**RE : Minor Project Modification #5 for the Riverside Transmission Reliability Project**

# MINOR PROJECT REFINEMENT REQUEST FORM

## **MPR 05 – RTRP Access Roads and Work Areas**

Southern California Edison (SCE)  
*Riverside Transmission Reliability Project (RTRP)*

**Modification 16 –Reroute Access Road to Const #6 (Figure 10)**

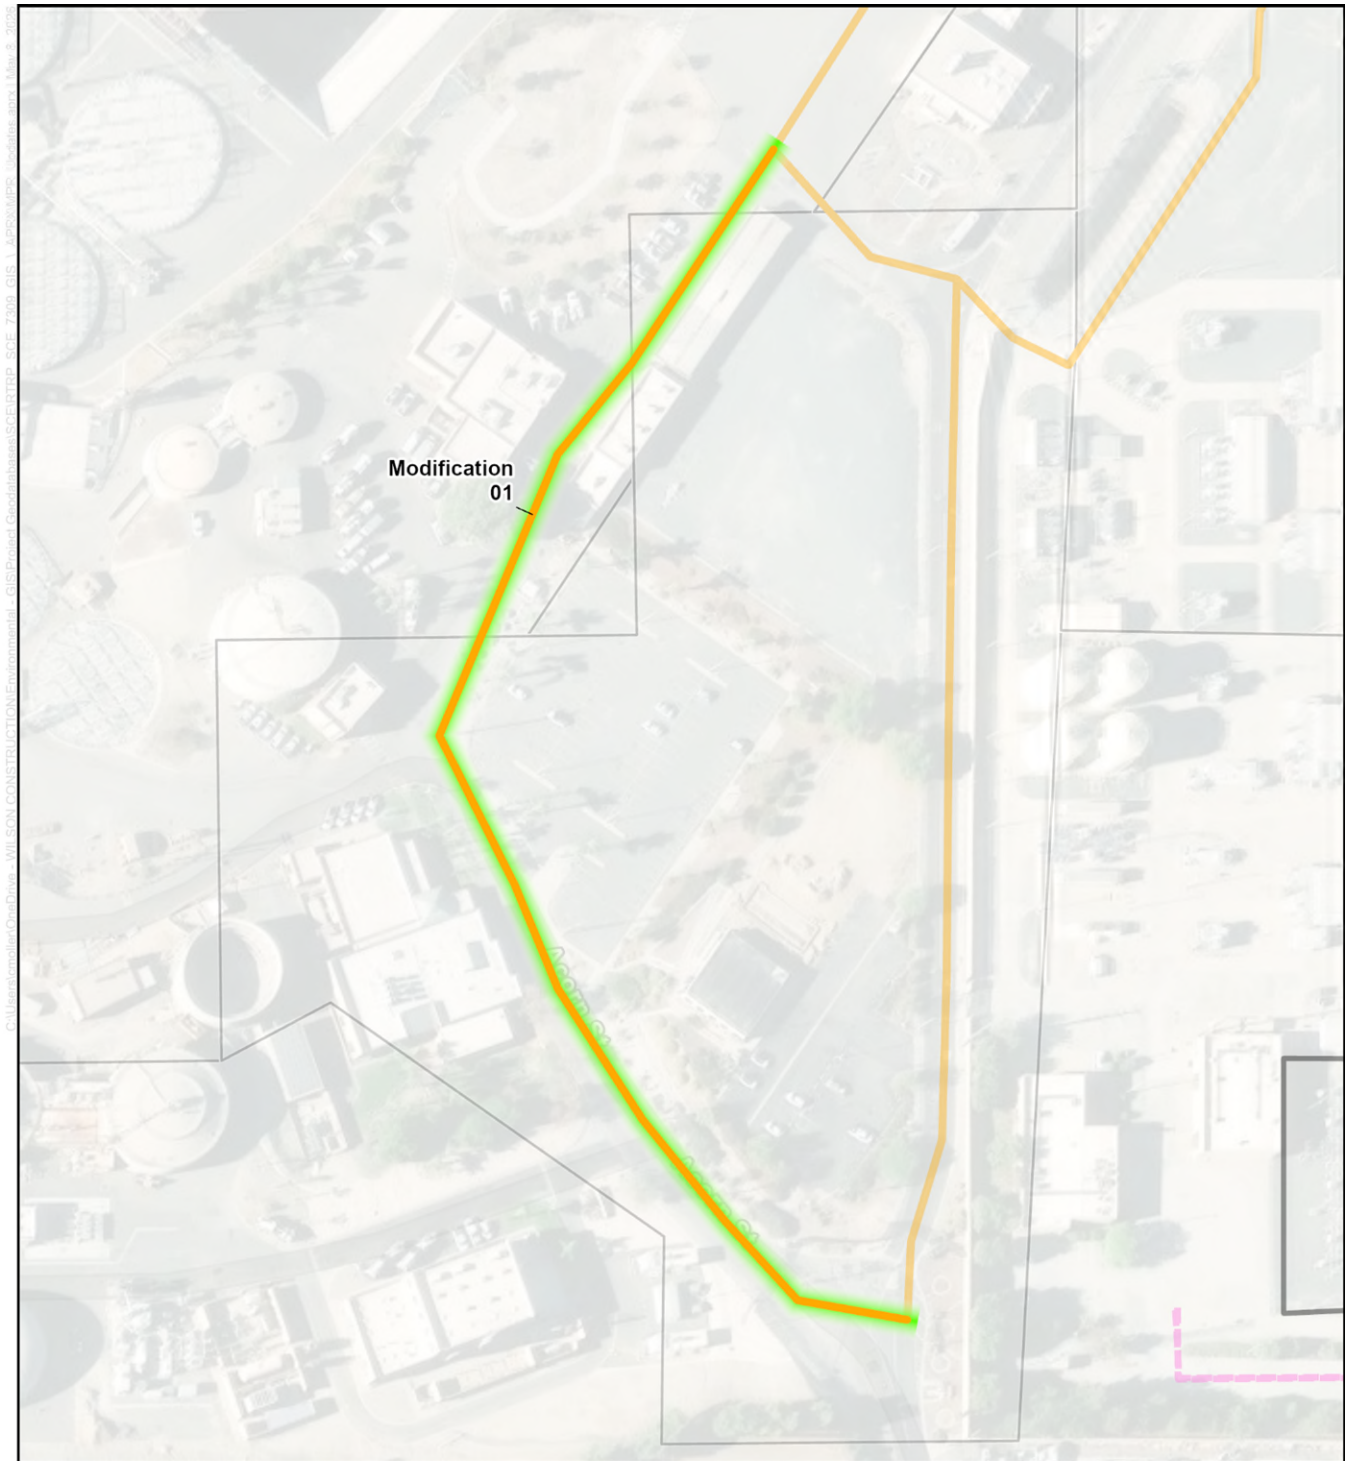
- Landowner: SCE
- Land Use: Developed area
- Proposing an existing road near Const #6 to create a travel loop from the parking area to current access within the nursery.
- Existing road with minimal improvements needed.

**Modification 17 – New Temporary Work Area at Const #6 (Figure 11)**

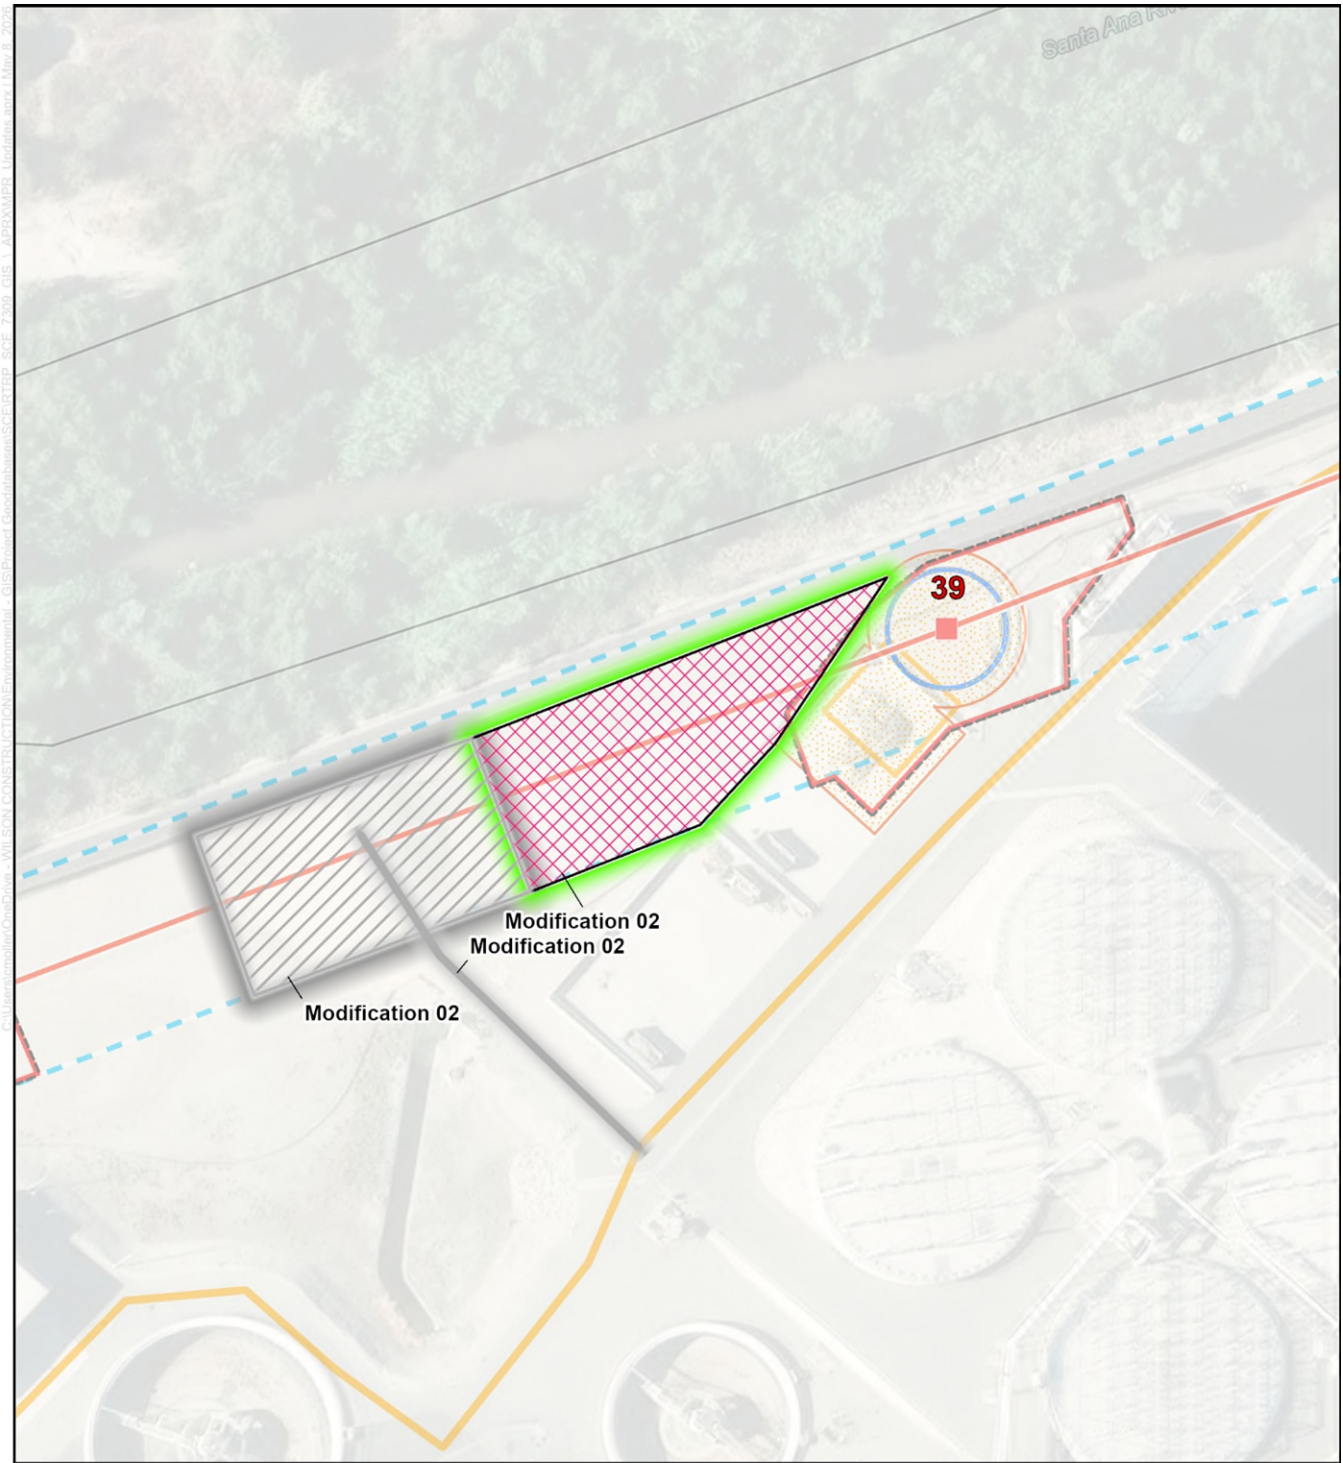
- Landowner: SCE
- Land Use: Developed area
- Proposed additional work area to close a gap in the current temporary work area within the ditch. Work will occur on either side of this gap, and travel will be needed through here. It's not possible to work around it due to the steepness of the existing slope.

**Figure 02 – Modification 02**

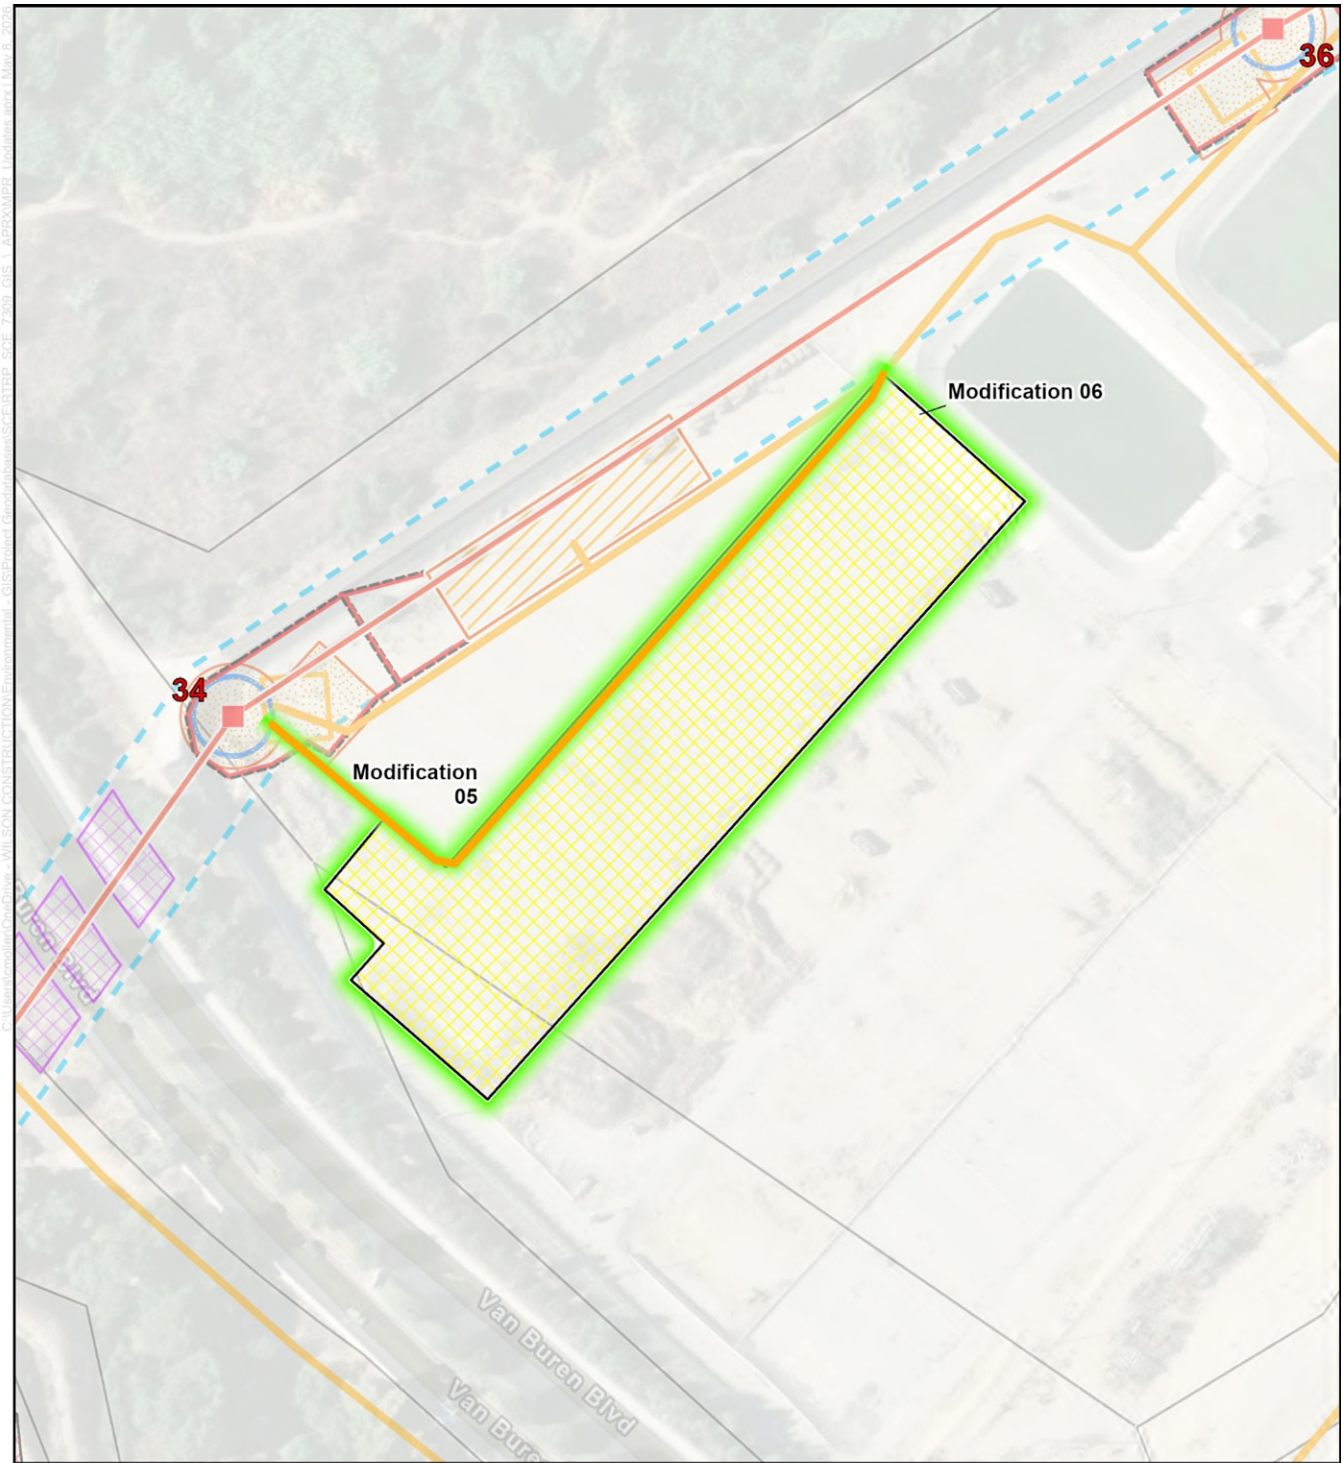
### **Modification 02 – Water Treatment Plant – Relocate Pull Site for Const #39 (Figure 02)**

- Landowner: City of Riverside
- Land Use: Public facilities
- Current pull site impedes fire safety ingress/egress road that cannot be blocked (per Kevin at water treatment plant). New proposed location connects with current work area and utilizes an existing flat area. Current pull site will be eliminated.
- Existing, paved previously disturbed area with no improvements needed

**Figure 04 – Modification 05 & Modification 06**

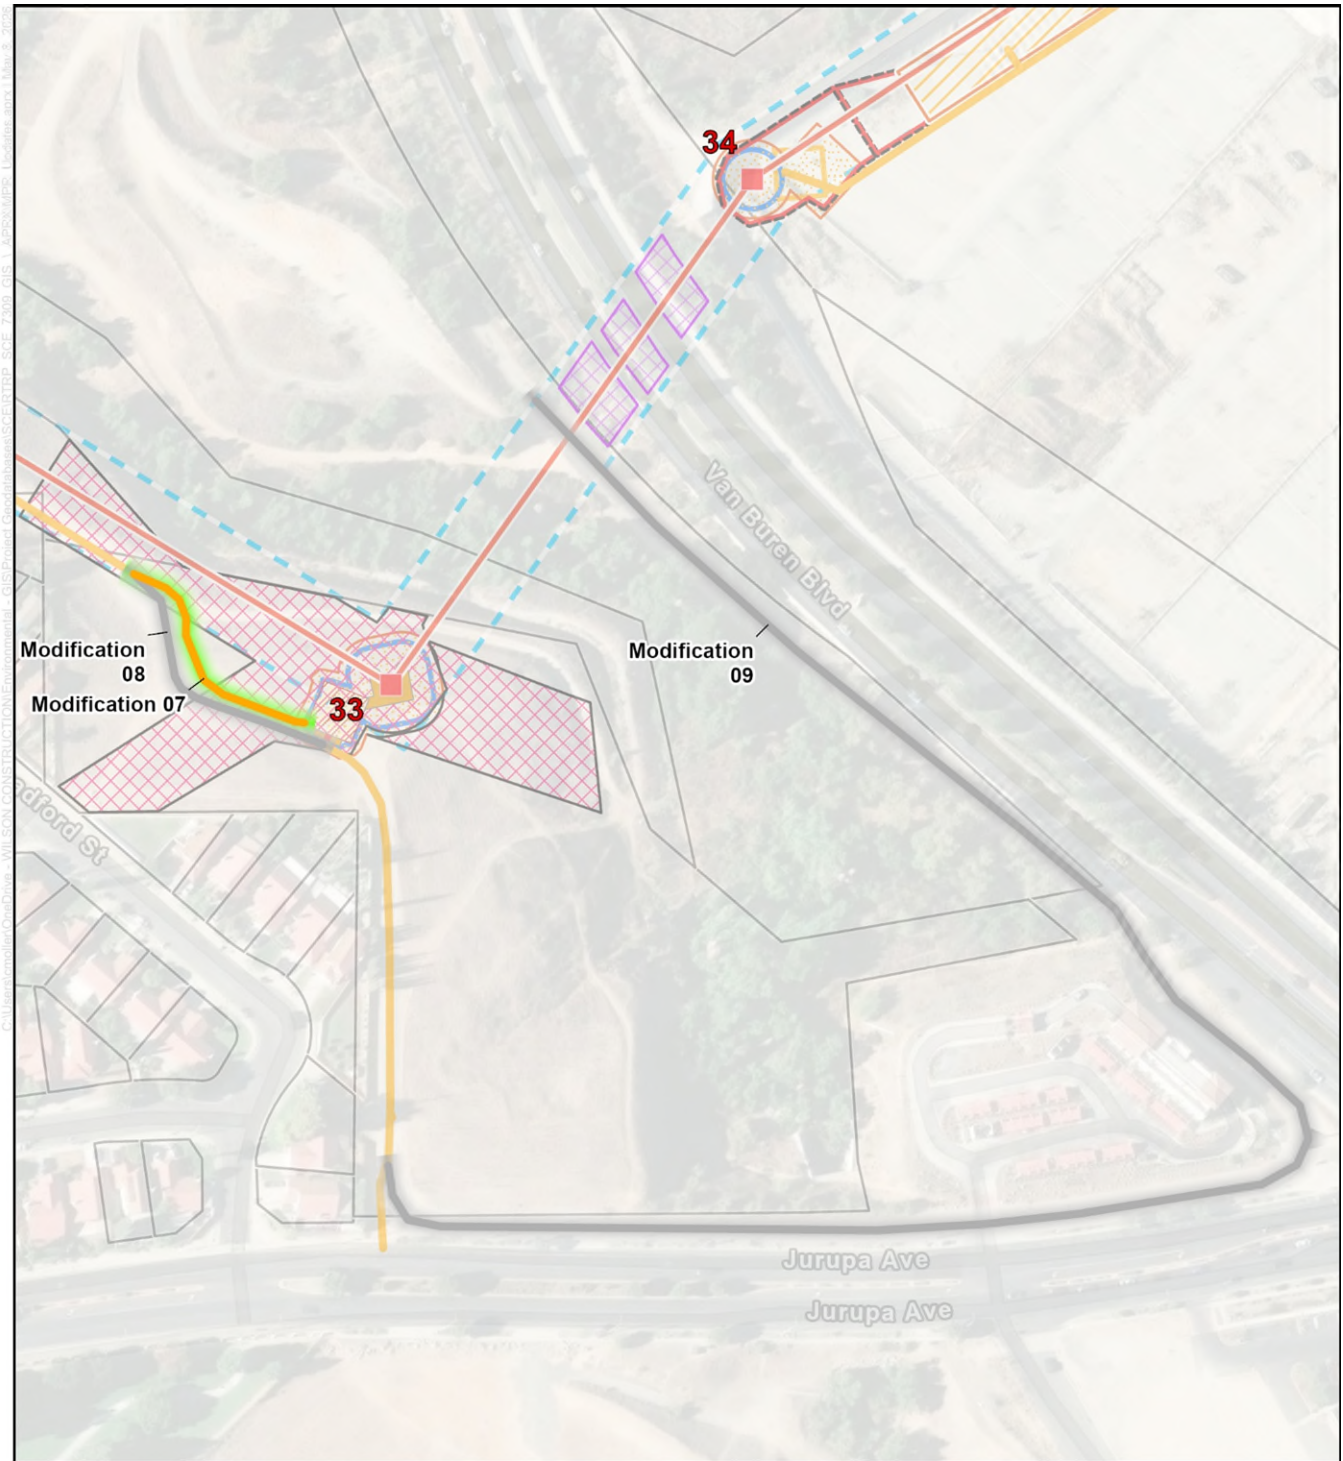
### **Modification 05 – Water Treatment Plant – Add Existing Access Road to Const #34 (Figure 04)**

- Landowner: City of Riverside
- Land Use: Public facilities
- Proposing an existing paved road to access Const #34 on the west side of the holding bay wall for equipment access.
- Existing paved road with no improvements needed.

### **Modification 06 – Water Treatment Plant – Add Temporary Work Area to Const #34 (Figure 04)**

- Land Use: Public facilities
- Proposing temporary work area to allow for equipment parking, material storage, and access to Const #34. The larger area was previously included in the Water Treatment Plant Work Plan.
- Existing disturbed paved site with no improvements needed.

**Figure 05 – Modification 07, Modification 08 and Modification 09**

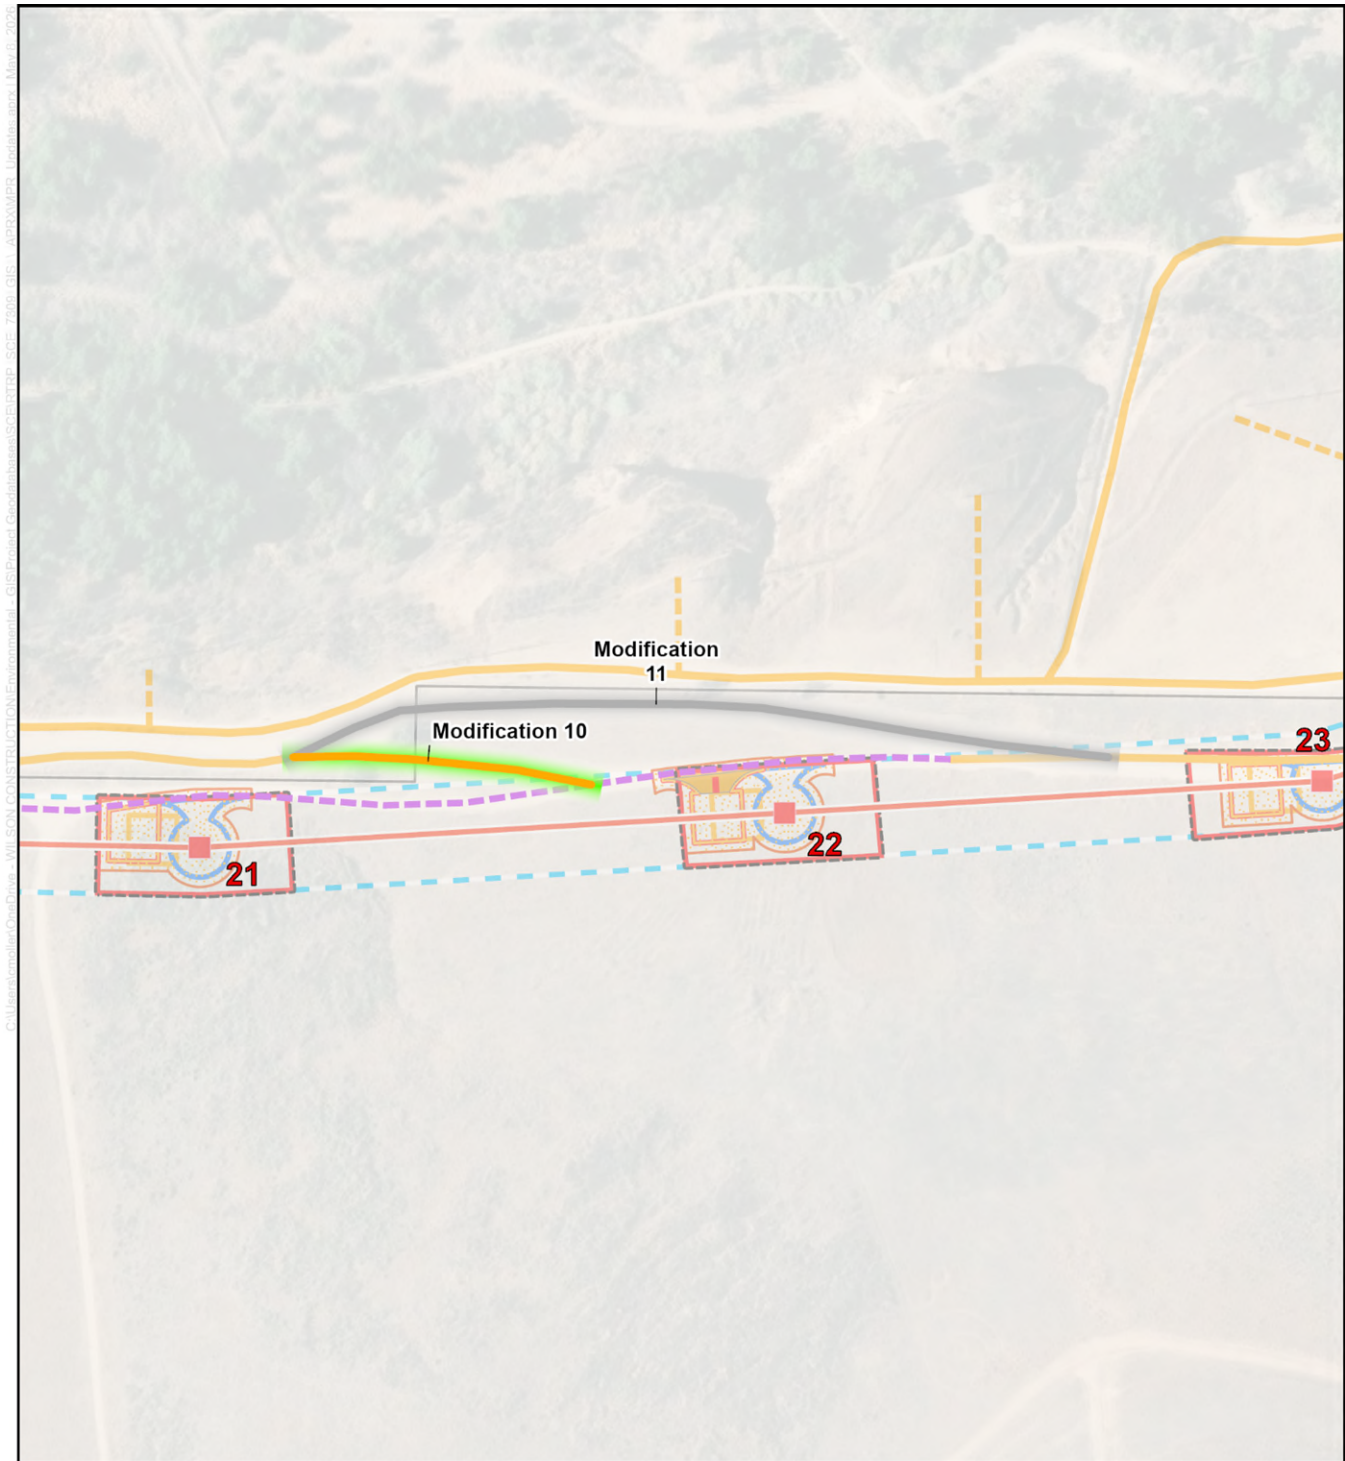
**Modification 07 – Reroute Access Road to Const #33 (Figure 05)**

- Landowner: City of Riverside/SART
- Land Use: Open space, recreational
- Proposing an existing Edison access road and gate to access the Const #33 work area and eliminate the previously proposed access road (see Modification 08 below).
- Existing road with no improvements needed.

**Modification 08 – Eliminate Access Road to Const #33 (Figure 05)**

- Landowner: City of Riverside/SART
- Land Use: Open space, recreational
- Proposed elimination of this road as it is blocked by concrete bollards and impassable/unusable. Will be replaced with an existing road (see Modification 07 above).

**Modification 09 – Eliminate Access Road to Const #33 Guard Location (Figure 05)**

- Landowner: City of Riverside/SART
- Land Use: Open space, recreational
- Proposed elimination of this road as it is blocked by concrete bollards and impassable/unusable.
